[2024/4371/P](#) Objection. The drawings are wrong and do not support the application.

Rochester Conservation Area

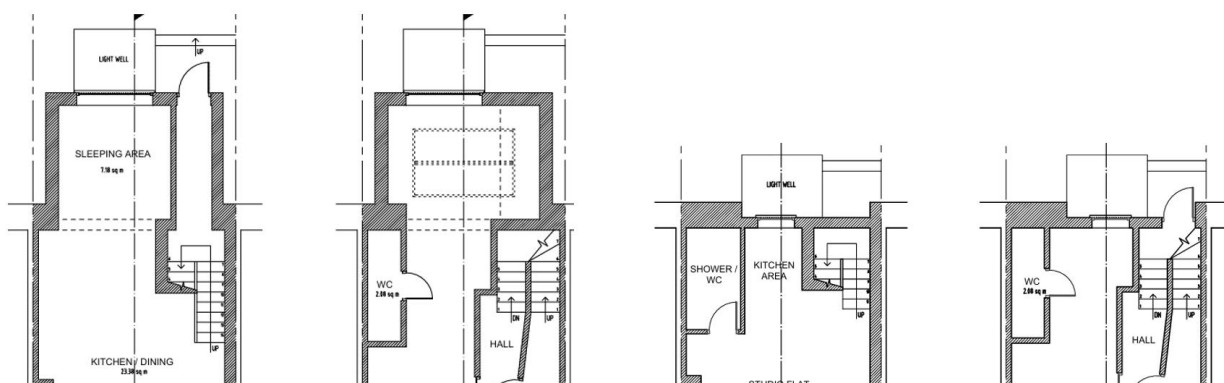
- The plan shows the new back door at basement level leading to a single garden step but the elevation is unchanged from before, at ground floor level.

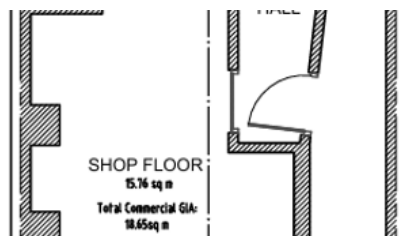
- The change of back door from ground floor to basement would make the previously suggested bike shed in the rear garden inaccessible.

- It is welcome that the ground-floor shop is re-instated, but wrong to have a door to the outside AND a door to the hallway. It should be clearly separated

- The façade of the shop front now has a door but the shape is wrong – the correct (wooden) façade can be seen in drawings for the earlier application for no. 156.

- The structure of the front wall is wrong – the front shop windows do not have a central column, yet one is shown.

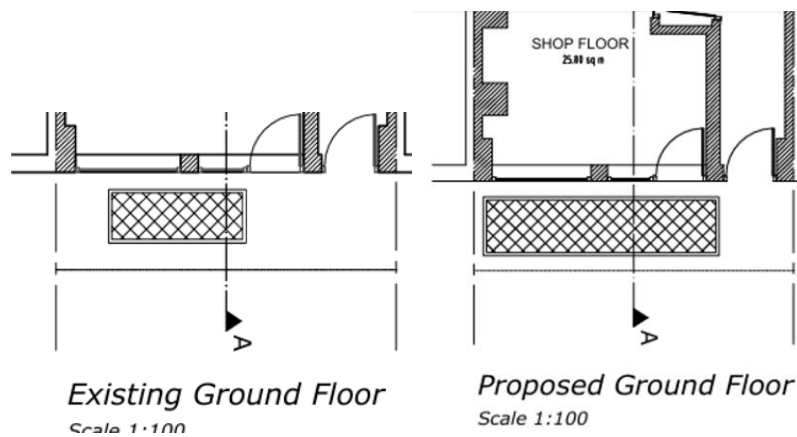
- The 'proposed' plan shows a widened front area grill extending across the shop doorway, which must be stone (preferably York stone) for the shop door entrance.

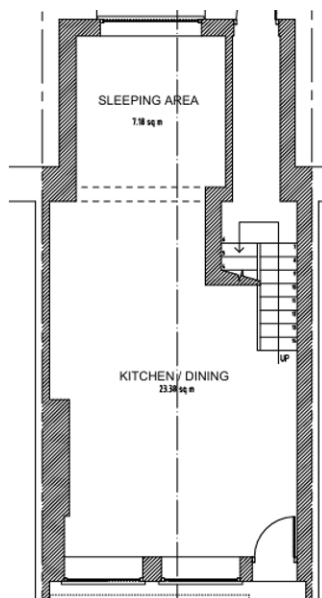
- The Officer's report on the previous application noted the recent road flooding which is not described in either basement assessment. **Impermeable glassbrick** is needed to replace the current smaller front basement grill, not a large open metal lattice.

- The basement has permission as a studio flat but lacks any bathroom facilities. It should not be dependent on the shop above.
